From: Oujevolk, Richard M <ROujevolk@dot.nv.gov>
Sent: Wednesday, March 21, 2018 1:06 PM
To: Melby, Karen
Cc: psolaegui@aol.com; scott@christynv.com; Sosa, Amber; Smaltz, Tara M; Pullen, Jae E; Gamez, Shelia; Diem, Paula J; Verre, Kevin F
Subject: RE: The Quarry (NDOT Pre-Permit 207543-18)

RE: The Quarry (NDOT Pre-Permit No. 207543-18)

DA18-0001/AX16-0003/
MPA17-00005/RZ17-0006
Jackling Aggregates, LLC/QK, LLC
The Quarry Development

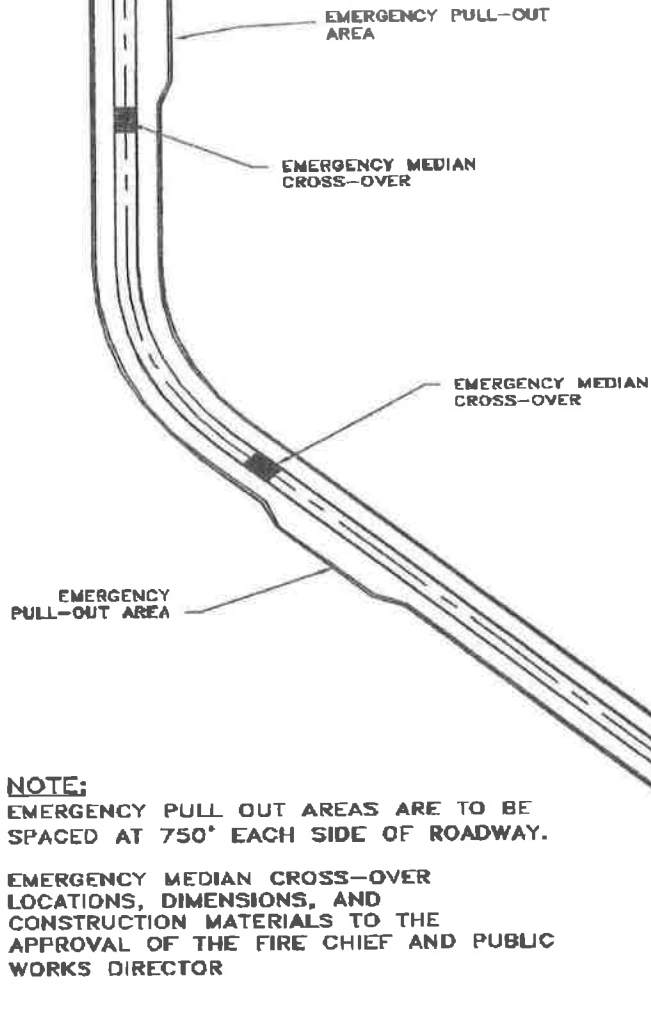
1. The developer only provides **one way in and out of the development**. He is proposing a two-lane road (20' wide each) off of Highland Parkway with a 10' wide median. This was just verbal discussion, I have not seen a proposed diagram yet.

- Fire department will require a letter of justification from the developer to be reviewed and approved by the Fire Chief.
 - Fire department will require another means of access/egress from this development. The timing of that means of access/egress will need to be discussed and approved by the fire department prior to approval of the development handbook.

- Fire department is requesting that Highland Parkway be widened from Pyramid Highway up to the entrance into this development, prior to the construction of homes. This will allow for better emergency responders access to the development entrance.

- Fire department will accept the 20' traffic lanes with a 10' median with the following provisions.
 - Emergency pull out areas are to be constructed to the approval of the Fire Marshal every 750' on each side of the roadway (see attachment).

- Emergency median cross-overs are also to be constructed to the approval of the Fire Marshal every 750' (see attachment).
 - Fire hydrants shall be located along this road at distances determined by the Fire Marshal.
